This page lists the known errors on the gm5x5x5 PCBs. There are no known issues with the bulk order run (white pcbs), the following information is valid **only** for the prototype run (green pcbs).

Prototype Run (green PCBs)

#1 MIDI IO pins

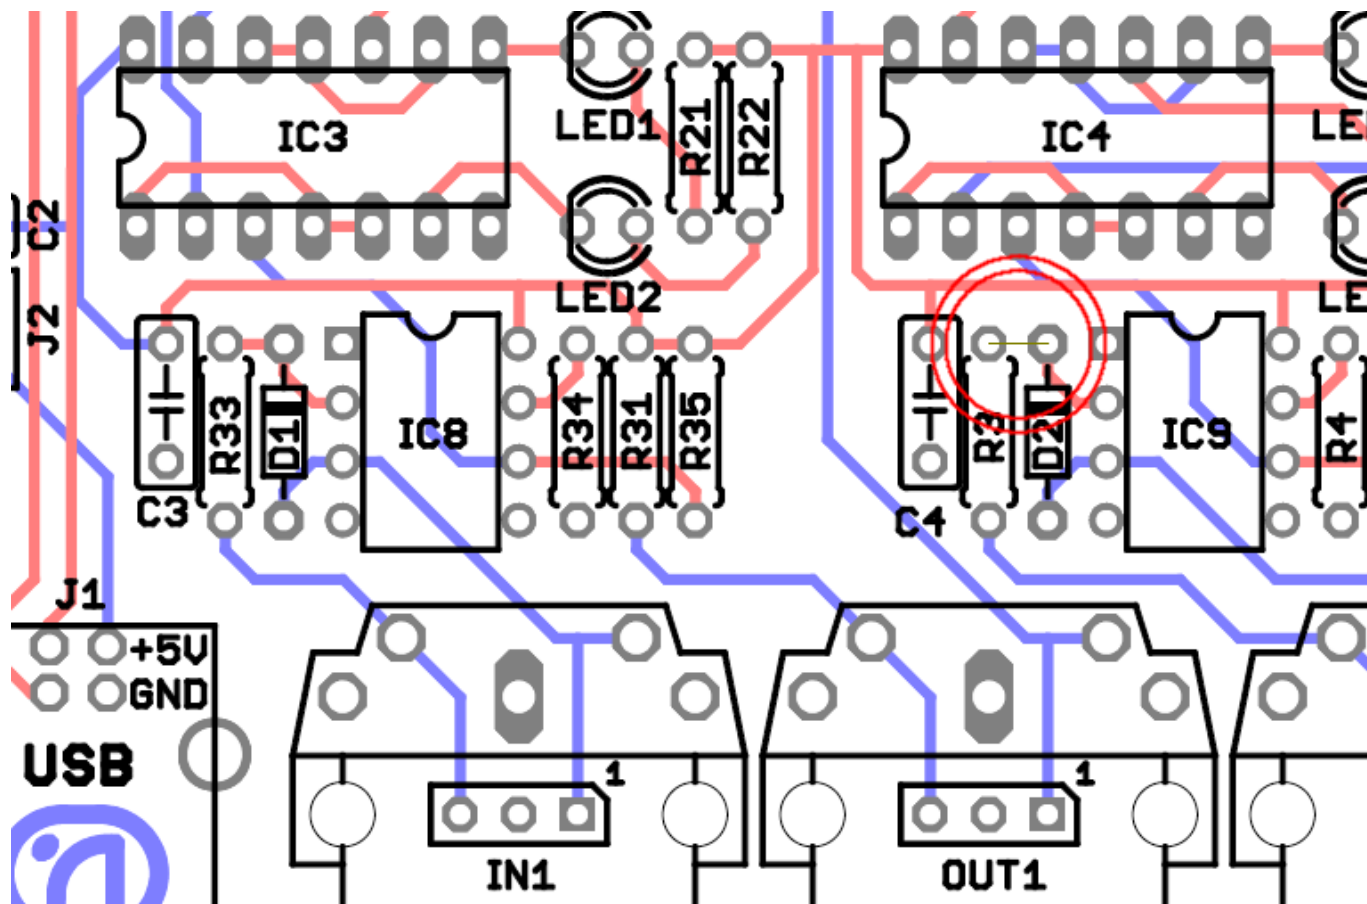
Problem: The MIDI IO pins of the midi sockets (Pin 4 + 5) are switched.

Solution: Either (1) use the pin-headers if you use sockets that are not mounted on the pcb or (2) break the traces to pins 4 + 5 of the sockets and solder wires to them or (3) solder the midi sockets on the other side of the pcb.
